**THE KING DAVID WAREHOUSING, INDUSTRIAL AND BUSINESS DEVELOPMENT BASIC ASSESSMENT**  
Traffic and Access

**THE KING DAVID WAREHOUSING, INDUSTRIAL AND BUSINESS DEVELOPMENT BASIC ASSESSMENT**  
**Traffic and Access**  
**DISCUSSION SUMMARY- FINAL**

**DATE:** 1 September 2017  
**VENUE:** Redefine  
2<sup>nd</sup> Floor  
Towers Link, The Towers  
2 Heerengracht Street  
Foreshore  
Cape Town  
8001  
**TIME:** 10h00 – 11h30  
**ARRANGED BY:** Chand  
**CHAIR:** Ms. Marielle Penwarden

Figure 1 Layout Option 1

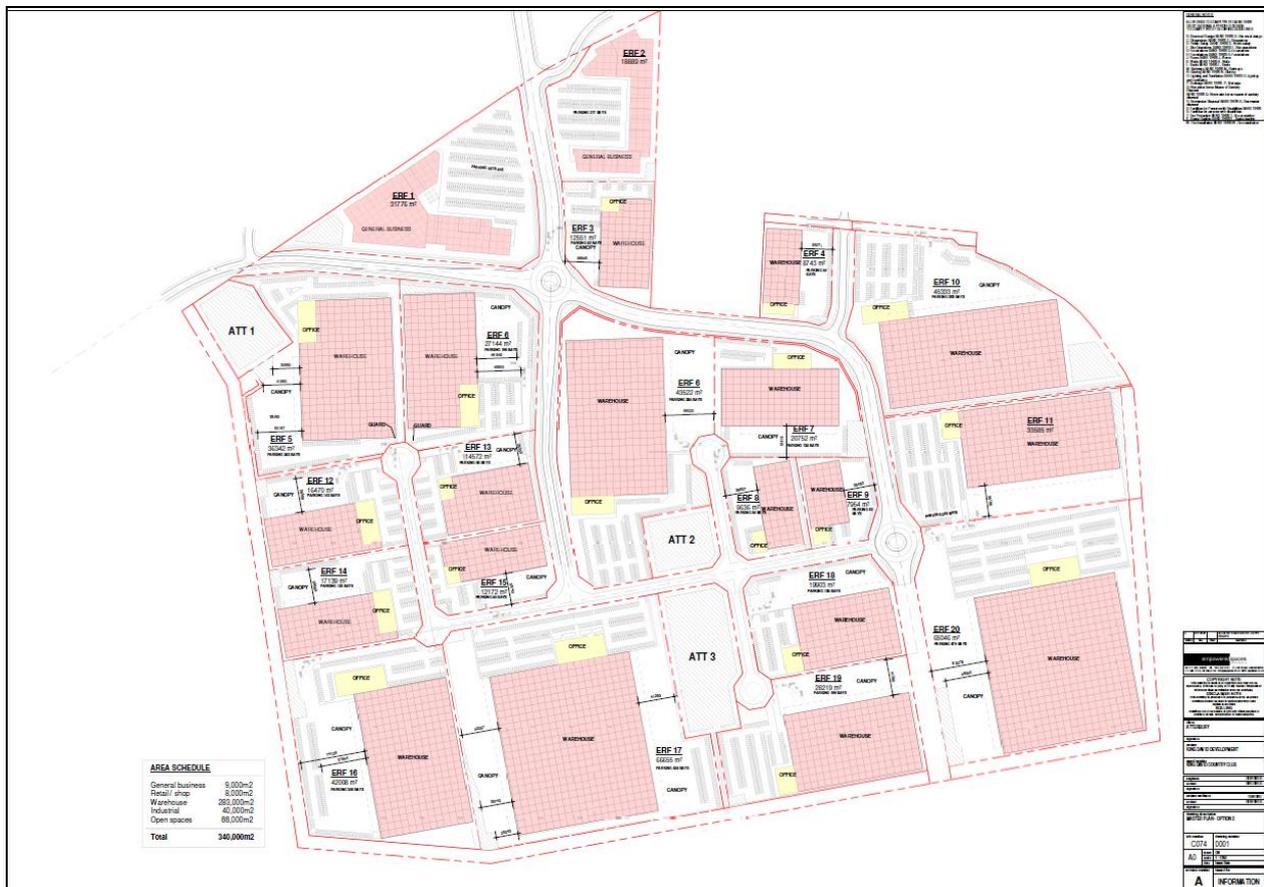
- JB explained that the applicant, King David Golf Club (Pty) Ltd (KDGC) is proposing a development comprising largely of industrial and warehousing and that the previous consideration of business use has been discarded. He indicated that two alternatives are under consideration (refer to Figure 1 and Figure 2).

- XR confirmed that Redefine favours Option 1 over Option 2.
- It was agreed that the possibility of shifting the access onto Pallotti Road a little to the east would be queried with the City of Cape Town.
